## URBAN DESIGN PANEL MINUTES

January 9, 2002

2. Address: 8982 Hudson Street  
DA: 406323  
Use: Residential (5 storeys)  
Zoning: C-2  
Application Status: Complete  
Architect: Nigel Baldwin  
Owner: Aragon Development Group  
Review: First  
Delegation: Nigel Baldwin, Thomas Woo, Gerry Eckford  
Staff: Eric Fiss

SOUTH ELEVATION (SOUTH WEST MARINE)

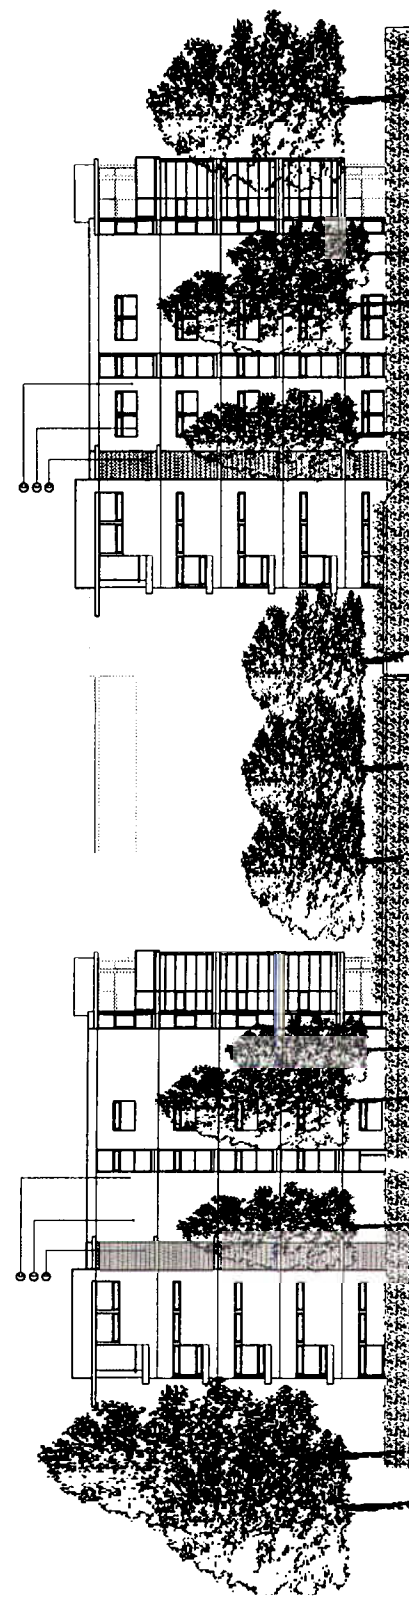
The materials and architectural expression were fully supported. It was not thought to be necessary to differentiate the expression of the top floor, in fact it would detract from the architectural expression sought to be achieved. There was a suggestion to cover the top floor access passage and to enclose the upper balconies to mitigate noise. One Panel member found the Marine Drive elevation somewhat severe and suggested something like corrugated panelling might be considered.

Some Panel members found the front entry to the building somewhat understated. As well, the Marine Drive elevation could have a little more substance given it is the front of the building and in the context of being somewhat of a gateway building in this location.

**Applicant's Response:** Mr. Baldwin commented the Marine Drive elevation has been particularly challenging. He said he felt he had no other choice with the north facade given the C-2 setback regulations.
